# **Site Accessibility Evaluation**

## **Title 24 And Part 2 - California Building Code**

**Central Library**  
**40 E Anapamu St**  
**Santa Barbara Downtown, CA 93101**  
**Accessibility Evaluation**  
**Inspection Date: 08/16/2023**  
**Inspectors: Scott Saddlemire**

**Report Date: 11/03/2023**

### Finding: 35

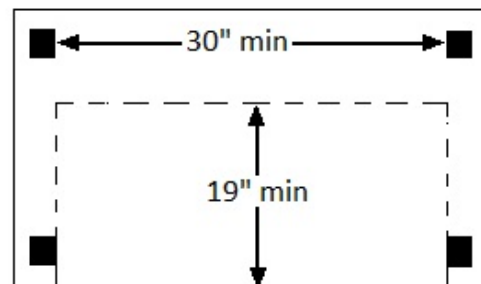
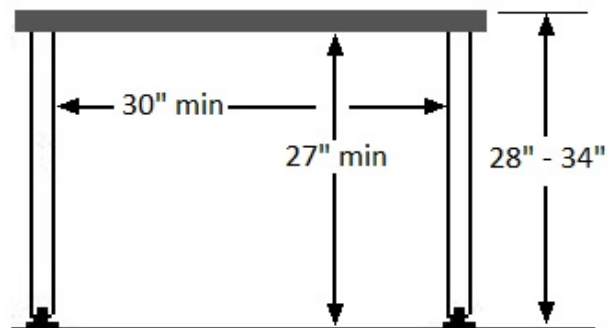
Compliant knee and toe clearance is not provided at the table.

When seating for persons in wheelchairs is provided at fixed tables or counters, knee spaces at least 27 inches high, 30 inches wide and 19 inches deep shall be provided.

Citation:	As Built:	Budgeting Range:
2022 CBC 11B Section: 11B-902.2	12 tables 4 with checker boards	\$1,500 - \$6,500.00

Install 5% compliant tables in each area and use

### Finding: 37

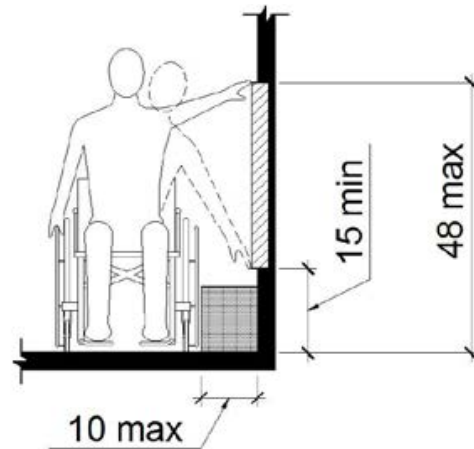
The element is out of the maximum allowable reach range for a side approach.

Where a clear floor or ground space allows a parallel approach to an element and the side reach is unobstructed, the high side reach shall be 48 inches maximum to the finished floor.

self serve book check out

### Finding: 38

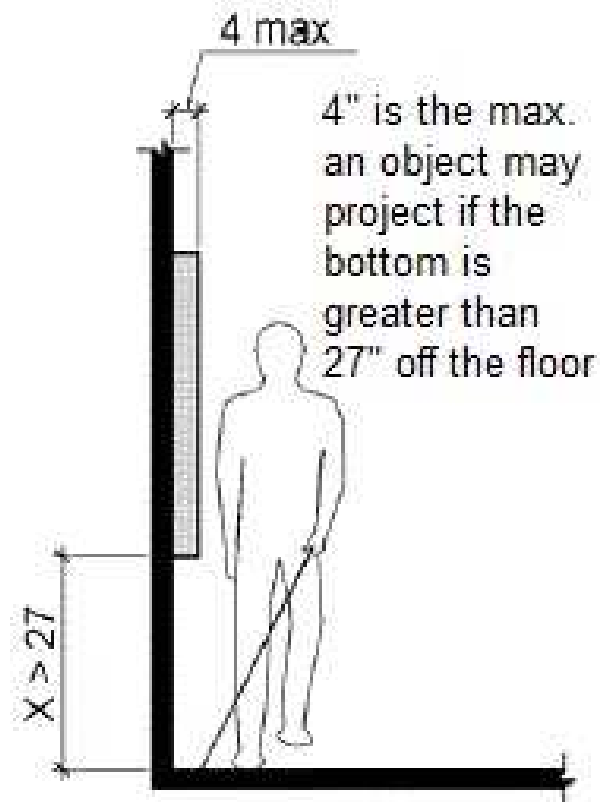
The element projects more than 4 inches into the circulation path.

Wall-mounted objects that have leading edges between 27 inches and 80 inches from the floor must not project more than 4 inches into the circulation path. Protruding objects that extend to the floor or within 27 inches of the floor are cane detectable and are therefore not hazardous. Where it is necessary or desirable to have objects protrude from the wall, a manner of cane detection must be provided.

### Finding: 39

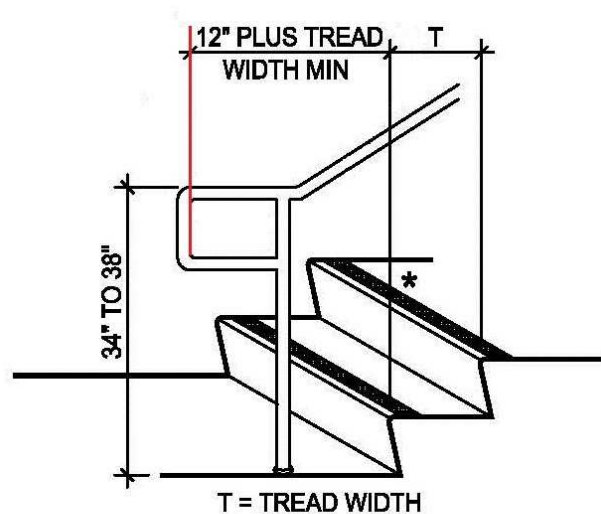
The handrail does not have a compliant extension at the bottom of the stair flight.

At the bottom of a stair flight, handrails shall extend at the slope of the stair flight for a horizontal distance equal to one tread depth beyond the last riser nosing. The horizontal extension of a handrail (not including the curved portion of round handrails) shall be 12 inches long minimum and a height equal to that of the sloping portion of the handrail as measured above the stair nosings. Extension shall return to a wall, guard, or the landing surface, or shall be continuous to the handrail of an adjacent stair flight.

Full length of extension must be  
**HORIZONTAL**

### Finding: 40

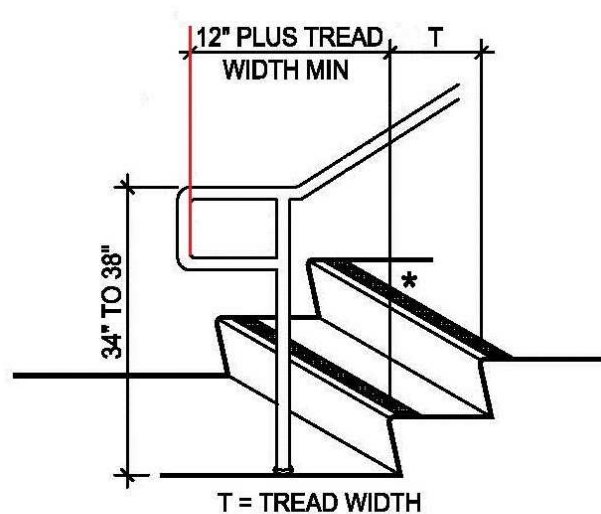
The handrail does not have a compliant extension at the bottom of the stair flight.

At the bottom of a stair flight, handrails shall extend at the slope of the stair flight for a horizontal distance equal to one tread depth beyond the last riser nosing. The horizontal extension of a handrail (not including the curved portion of round handrails) shall be 12 inches long minimum and a height equal to that of the sloping portion of the handrail as measured above the stair nosings. Extension shall return to a wall, guard, or the landing surface, or shall be continuous to the handrail of an adjacent stair flight.

Full length of extension must be  
**HORIZONTAL**

### Finding: 41

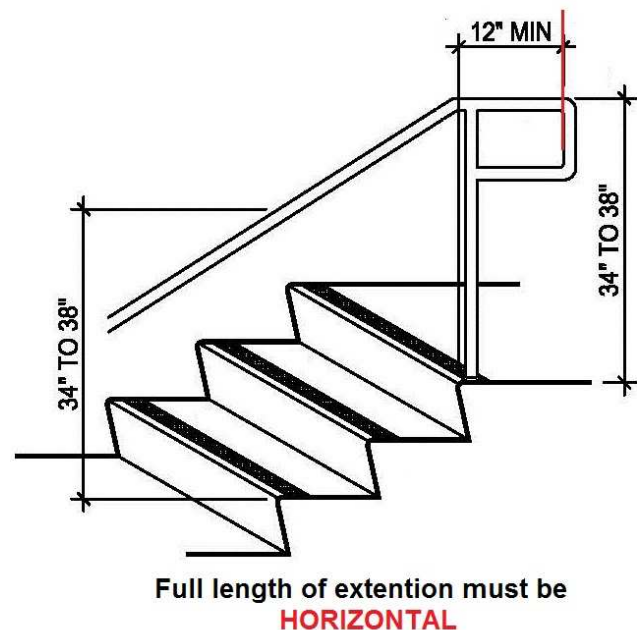
The handrail extensions do not begin directly above the first nosing.

At the top of a stair flight, handrails shall extend horizontally above the landing for 12 inches minimum beginning directly above the first riser nosing. Extensions shall return to a wall, guard, or the landing surface, or shall be continuous to the handrail of an adjacent stair flight.

### Finding: 44

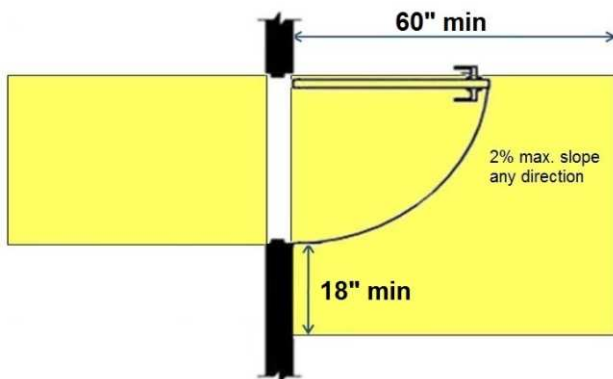
The maneuvering clearance on the pull side of the door extends less than 18 inches beyond the latch side of the door.

Maneuvering space for interior doors on the pull side with a front approach must be flat (2% max. slope in any direction) for a minimum distance of 60 inches in the direction of travel. The width of the maneuvering space must be as wide as the door plus an additional 18 inches on the latch side. This latch side clearance must also be flat (2% max. slope in any direction) and clear of obstructions.

### Finding: 45

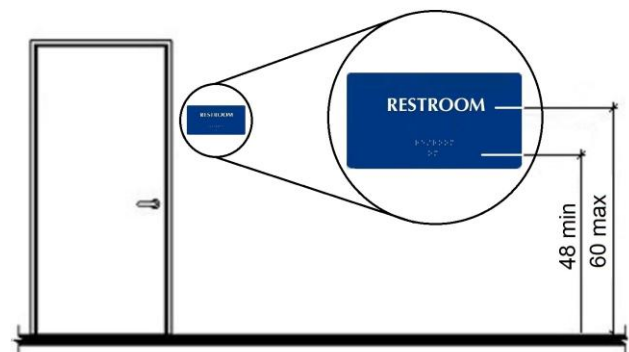
A compliant room identification sign is missing on the strike side of the door.

Wall signs identifying permanent rooms and spaces of a building shall have be horizontal format and the characters raised 1/32 inch minimum and shall be sans serif uppercase characters a minimum of 5/8 inch and a maximum of 2 inches high. Contracted Grade 2 Braille shall be in a horizontal format and shall be placed a minimum of 3/8 inch and a maximum of 1/2 inch directly below the tactile characters; flush left or centered. Signs with raised characters or Braille shall be located a minimum of 48 inches above the finish floor or ground surface, measured from the baseline of the lowest line of Braille and 60 inches maximum above the finish floor or ground surface, measured from the baseline of the highest line of raised characters.

### Finding: 46

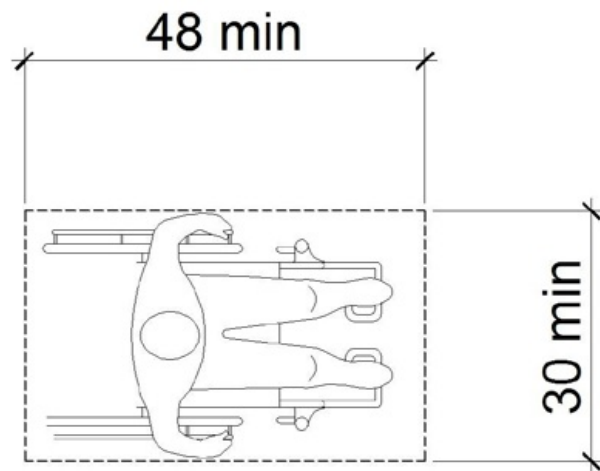
The lavatory's clear floor space obstructed by the trash can.

The wall mounted trash can projects (XX) from the wall and encroaches into the required 30 inches by 48 inches clear floor space. The maximum projection that a dispenser may project at this location is (XX) inches.

### Finding: 47

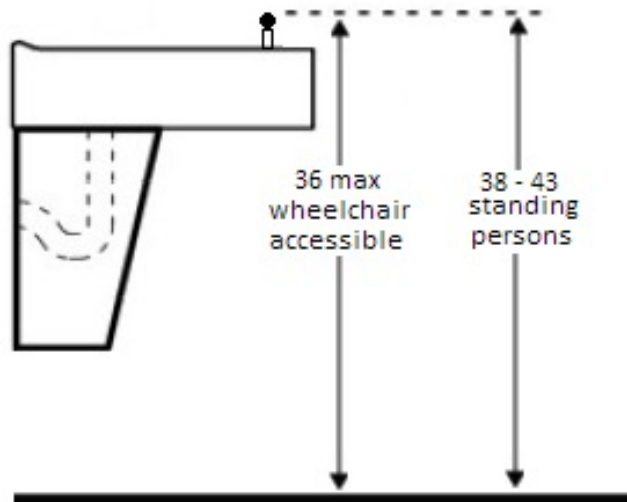
The total number of drinking fountains are not equally divided between those that are accessible to wheelchair users and those that are available to standing persons.

Where more than two are provided, 50 percent of the total number of drinking fountains provided shall be accessible to wheelchair users and 50 percent available to standing persons.

Where 50 percent of the drinking fountains yields a fraction, 50 percent shall be permitted to be rounded up or down provided that all drinking fountains complies with either requirements for wheelchair users or standing persons.

### Finding: 48

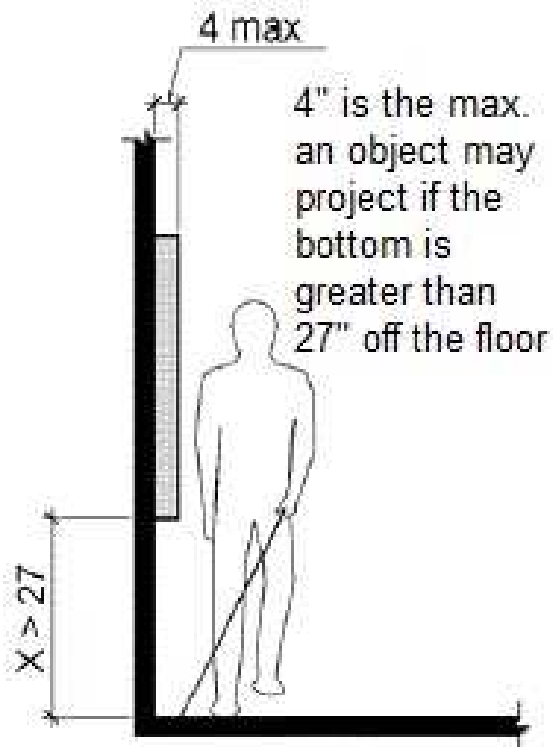
The element projects more than 4 inches into the circulation path.

Wall-mounted objects that have leading edges between 27 inches and 80 inches from the floor must not project more than 4 inches into the circulation path. Protruding objects that extend to the floor or within 27 inches of the floor are cane detectable and are therefore not hazardous. Where it is necessary or desirable to have objects protrude from the wall, a manner of cane detection must be provided.

When only a low drinking fountain is installed, and is set exactly at 27" to the bottom apron, then no cane detection is required.

If a Hi/low set of drinking fountains are set, then cane detection will required

### Finding: 49

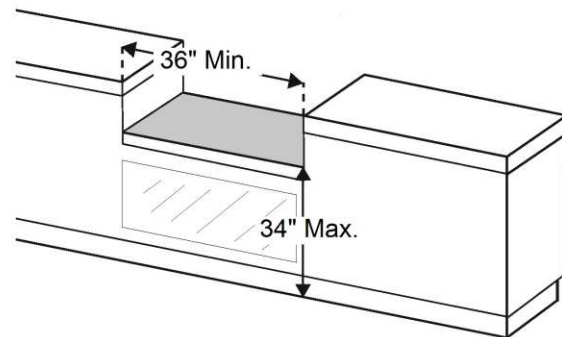
All service counters must be a maximum 34" A.F.F.

A portion of the counter surface that is 36 inches long minimum and 34 inches high maximum above the finish floor shall be provided. A clear floor or ground space complying shall be positioned for a parallel approach adjacent to the 36 inch minimum length of counter.

### Finding: 51

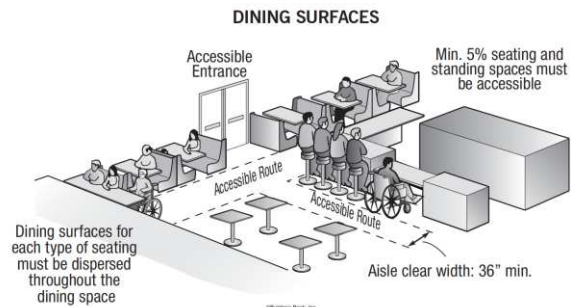
There are not enough accessible tables.

At least 5% of the seating in each functional area must be accessible. An accessible table must be on an accessible route (36 inches minimum) and have knee spaces at least 27 inches high, 30 inches wide and 19 inches deep. The tops of tables and counters must be 28 inches to 34 inches from the floor or ground.

Typical through library

### Finding: 56

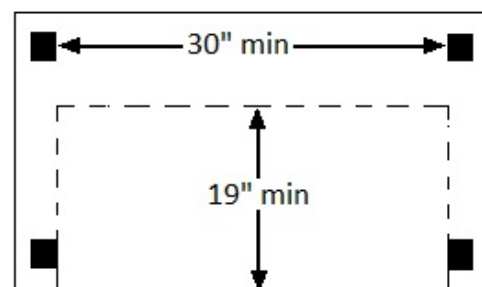
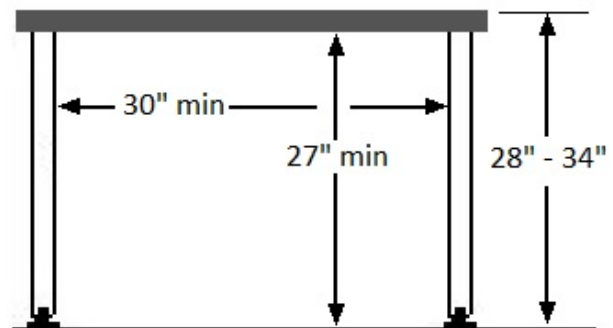
Compliant knee and toe clearance is not provided at the table.

When seating for persons in wheelchairs is provided at fixed tables or counters, knee spaces at least 27 inches high, 30 inches wide and 19 inches deep shall be provided.
